SERVICE INFORMATION No. SI 40-098

GARMIN Software Service Bulletin No.: 0846 Revision A
ATA-Code: 34-00

NO.: 0846 Revision A

SUBJECT: GTX 330/330D and GTX 33/33D Software Version 6.00 Non-G1000/G900X Applications Only

Figure 1

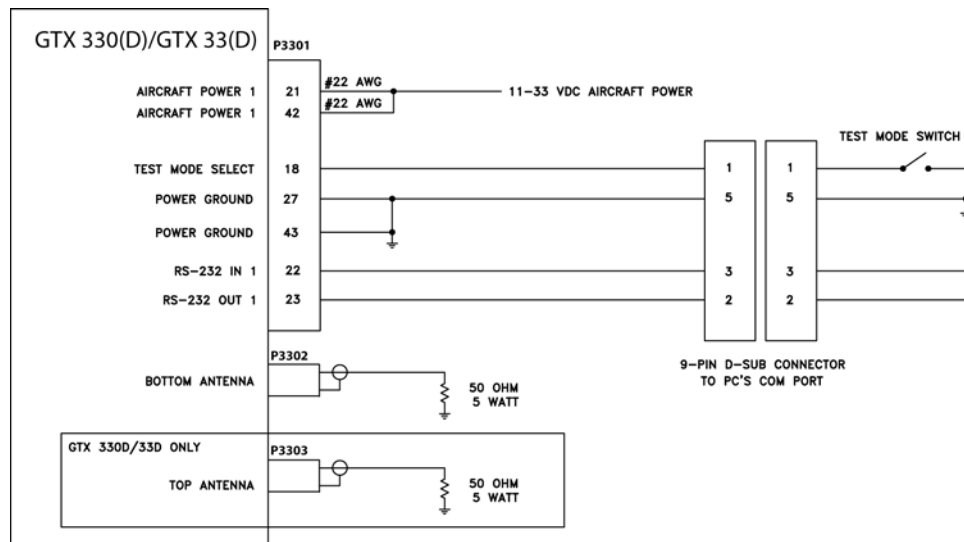
1. Use a test harness as shown in Figure 1.

If the unit is removed from the aircraft and operated, always connect J3302 (GTX 330/GTX 33) and J3303 (GTX 330D/GTX 33D) to a 50 Ω , 5-watt load. The GTX transmits Mode S acquisition squitter replies once per second whether interrogations are received or not. Failure to connect a dummy load or antenna during this procedure will cause the transponder to fail.

2. Ensure the unit is turned off. Connect the GTX to the test harness and apply power to the harness.
3. With the unit off, enable test mode via the Test Mode Switch. (Applies a ground to P3301 pin 18).
